Draft Off-Cycle Emissions GTR 14 and 15 September, 2005 Note:

Edits from 1st Editorial Committee meeting are in **Red** Edits from 2nd Editorial Committee meeting are in **Blue**

Editorial Note: The following text in green has been redrafted by the Chairperson for further consideration by the editorial committee.

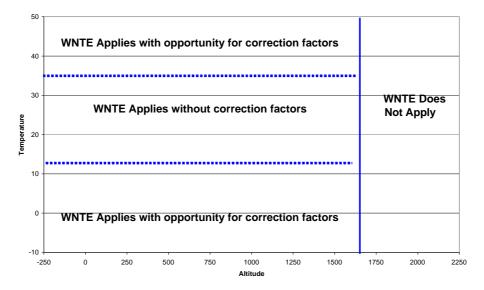
Editorial Comment: Editorial Committee has identified the altitude cut point as an issue to be further discussed by the Plenary group.

[Editorial comment: EMA and OICA would like the current altitude value to be expressed in an equivalent barometric pressure value]

Figure 1. Example Not-To-Exceed Control Area When NTE C Speed < 2,400 rpm

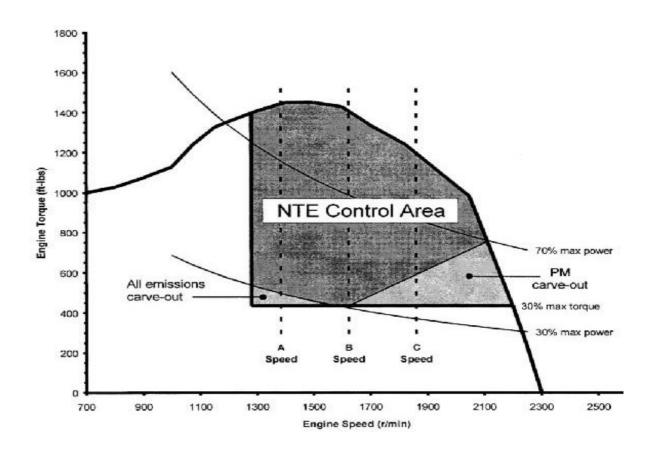
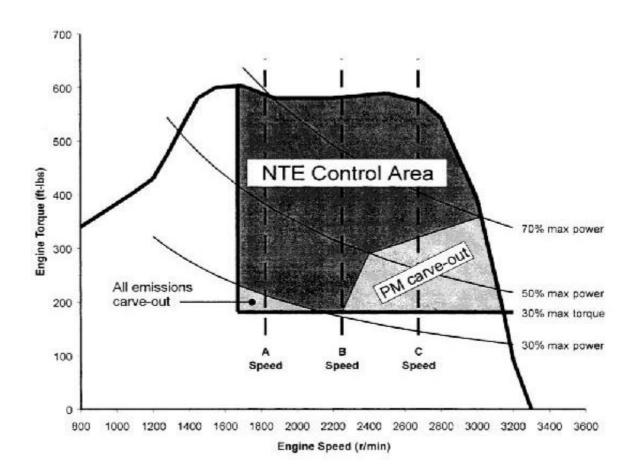
Editorial Comment: The method for determining the B and C speeds should be described herein.

Editorial Comment: Will update diagrams to correspond with final control area established in GTR and will add example figures without PM carve out.

NOTE: JAPAN EXPRESSED CONCERN WHETHER NTE WOULD CAPTURE SUFFICIENT TRANSIENT OPERATION WHICH IS A PREDOMINATE OPERATING MODE IN CITIES. JAPAN SUGGESTED NTE ZONE MIGHT NEED TO BE MADE LARGER OR AVERAGING TIME SHORTER. EDITORIAL COMMITTEE DISCUSSED HOW SHORTER AVERGING PERIOD MAY CAPTURE INFREQUENT EMISSIONS PEAKS AND COULD CHALLENGE PEMS ACCURACY CAPABILITY. OVERALL AFFECT COULD DRIVE A HIGHER NTE LIMIT AND REDUCE OVERALL ENVIRONMENTAL BENEFIT OF THE NTE.
